re: MP 08_0085 Goodman Fielder Production Facility

Reference is made to your email correspondence dated 7 July 2008 requesting comments in reply to the submissions to the exhibition of the Environmental Assessment. We reply as follows.

Goodman Fielder Erskine Park
Production Facility

Response to Submissions –
Attachment 1

08_017 L01 / 04

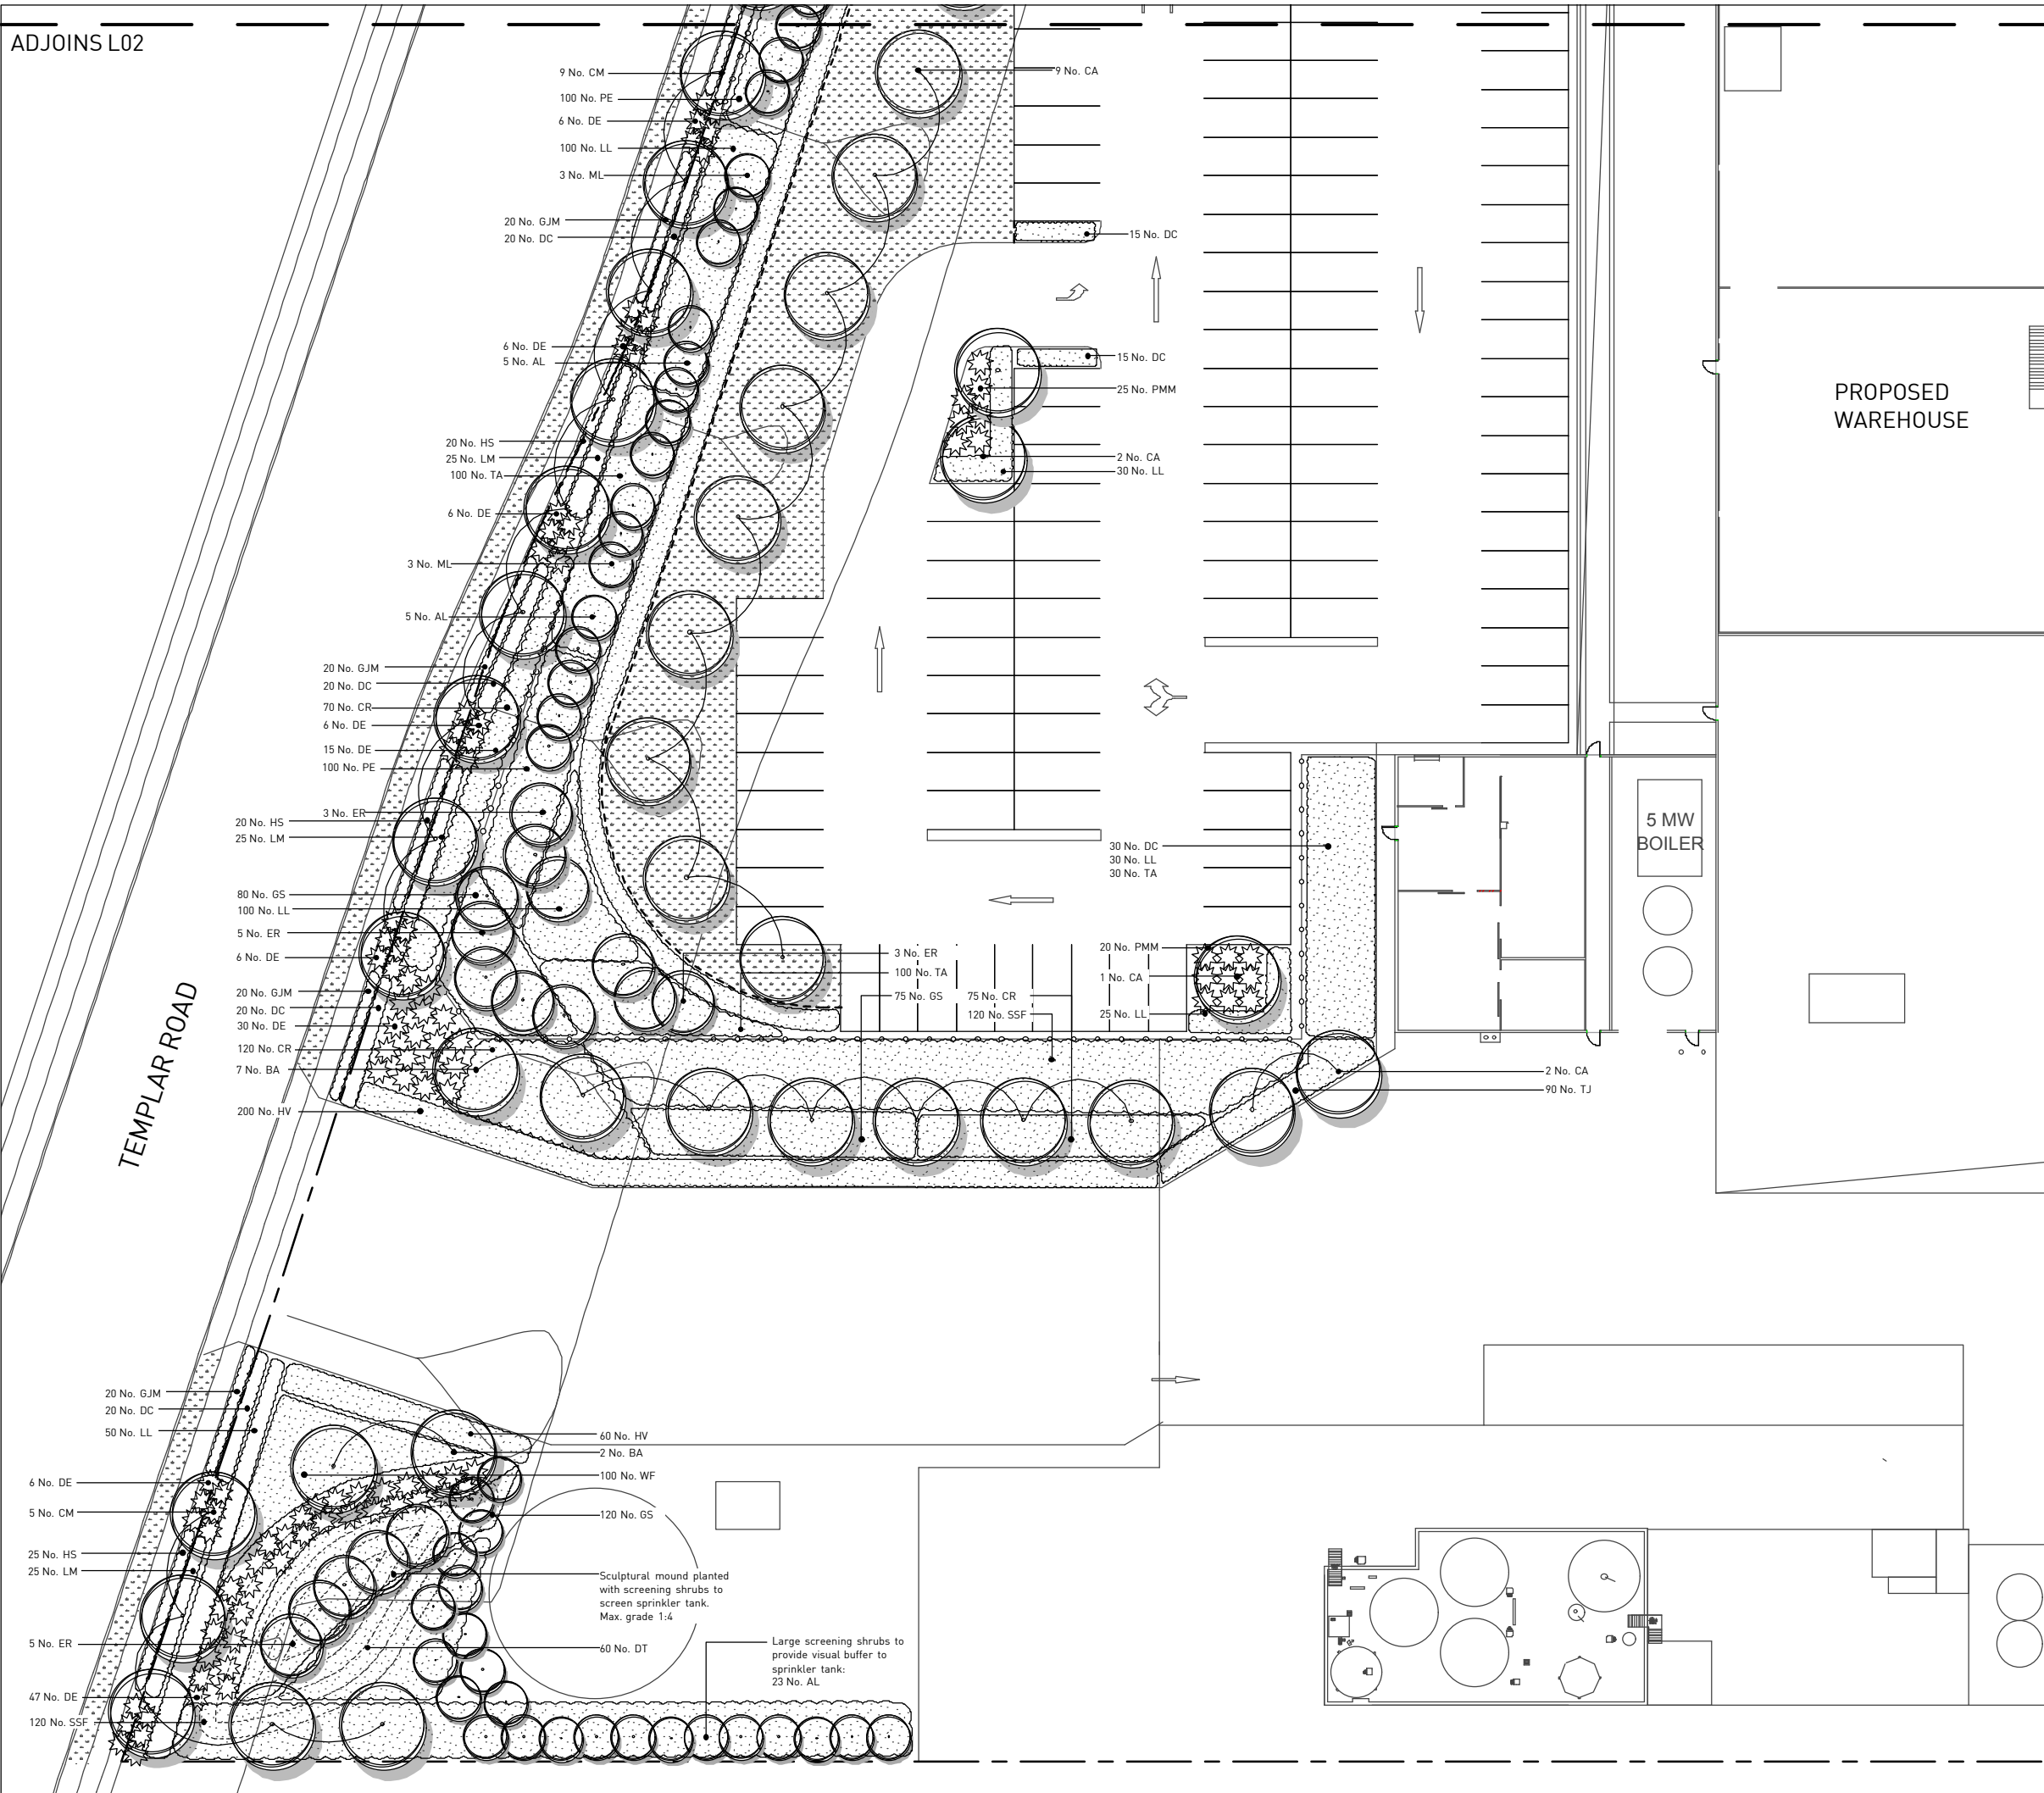
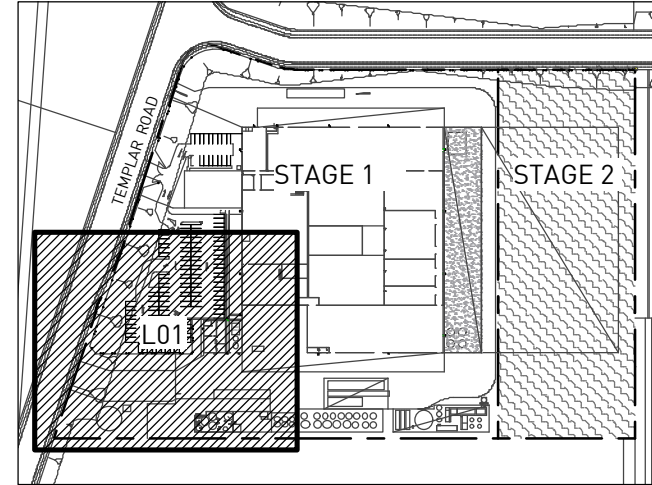
Attachment 2 contains revised landscape drawings L01/04 Issue C, L02/04 Issue C, L03/04 Issue C and L04/04 Issue C providing information on the temporary treatment of the Stage 2 development area which is to be the subject of a separate application. The area will be hydromulched and maintained as such until future expansion occurs. This has been noted on the plans with specification notes added to L04.

CARPARK ENTRY AMENDED	NB	7/7/08	C
CLIENT ISSUE	NB	10/4/08	B
PURPOSE OF ISSUE	NB	3/4/08	A
	REVIEW	DATE	ISSUE

SECTION A
25067DA03

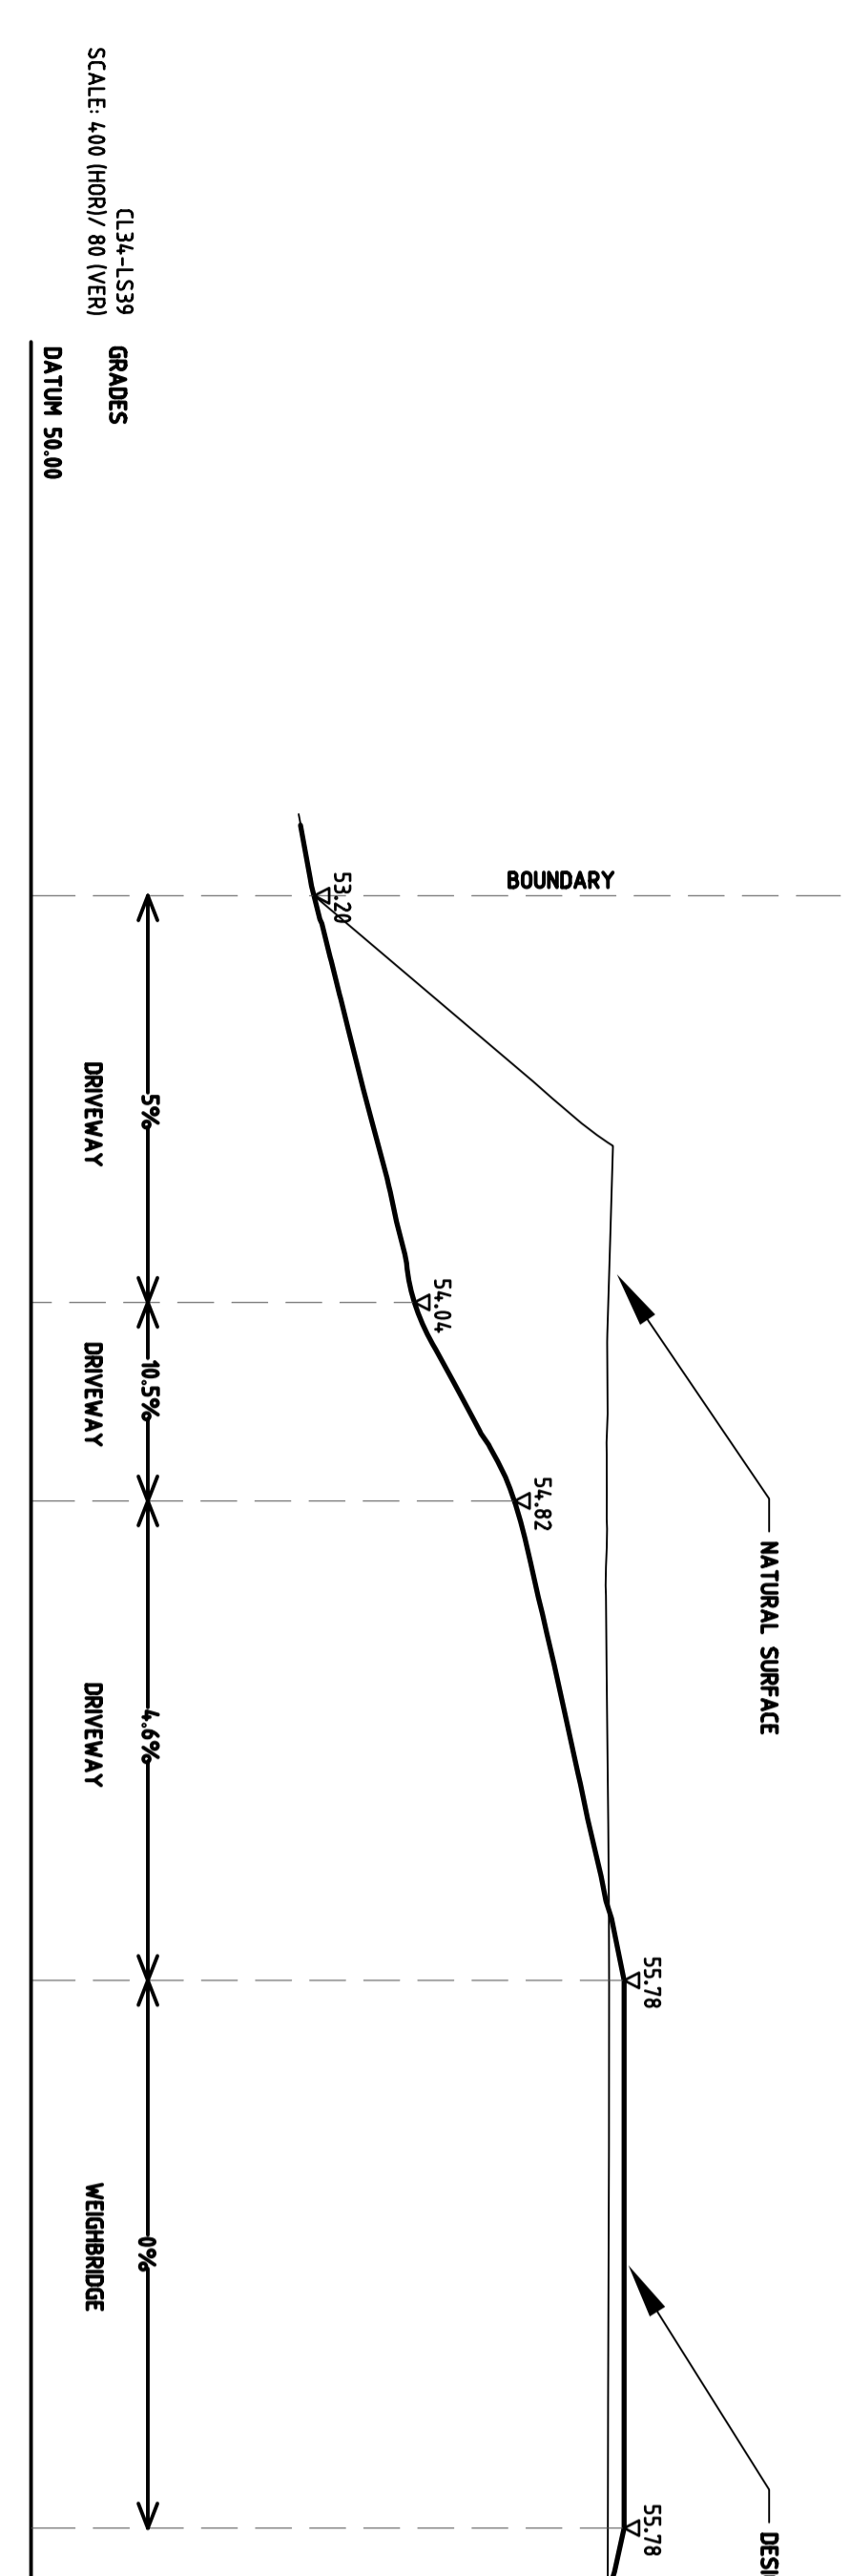
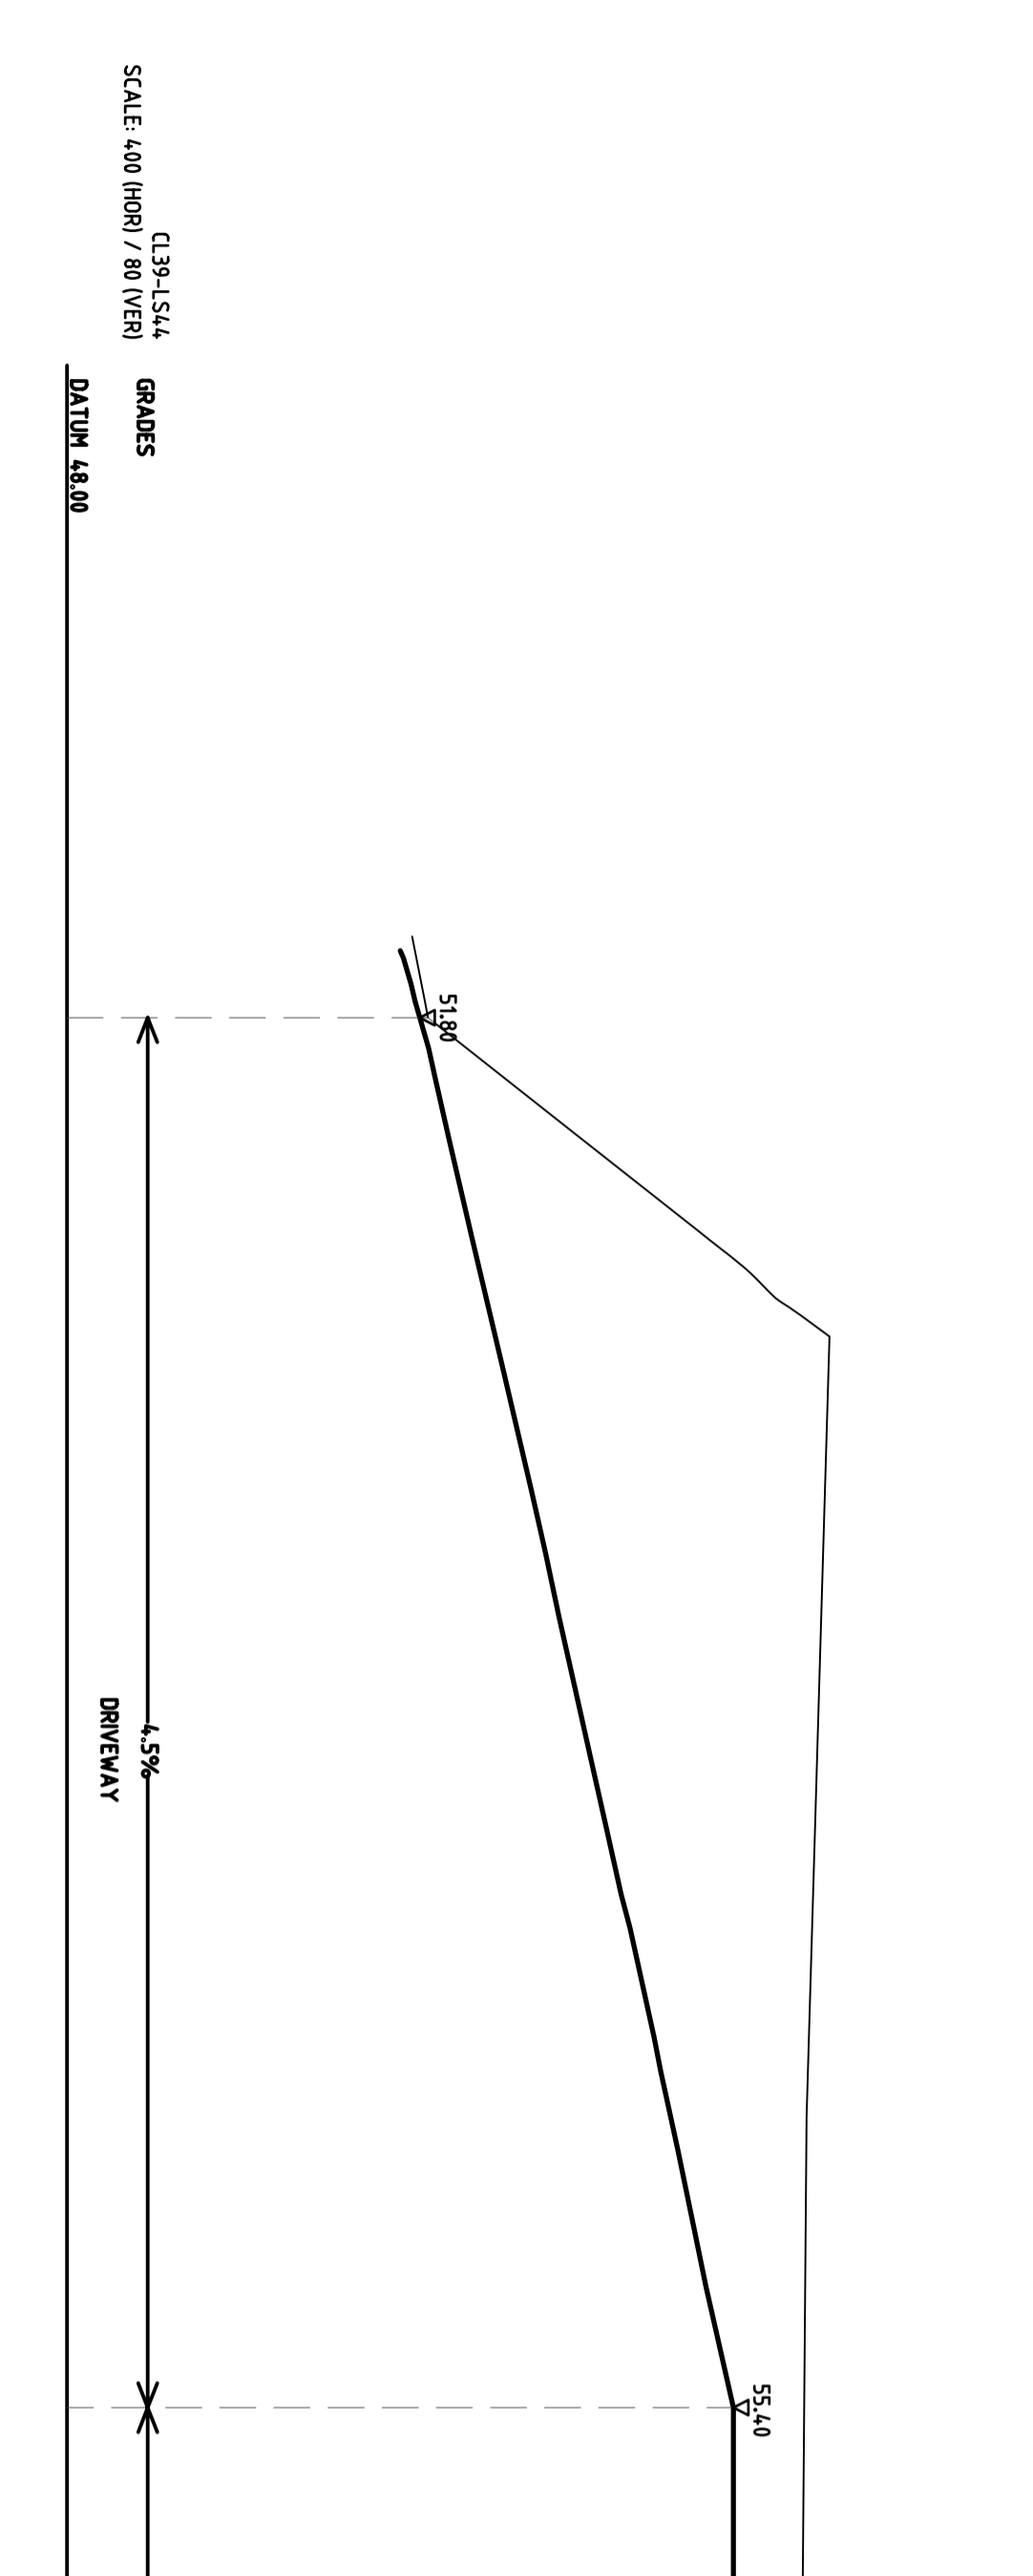
Long Sections of the driveways indicating grades are contained in the attached drawings prepared by Buckton Lysenko (Attachment 4). Buckton Lysenko advises that the design complies with the relevant standards.
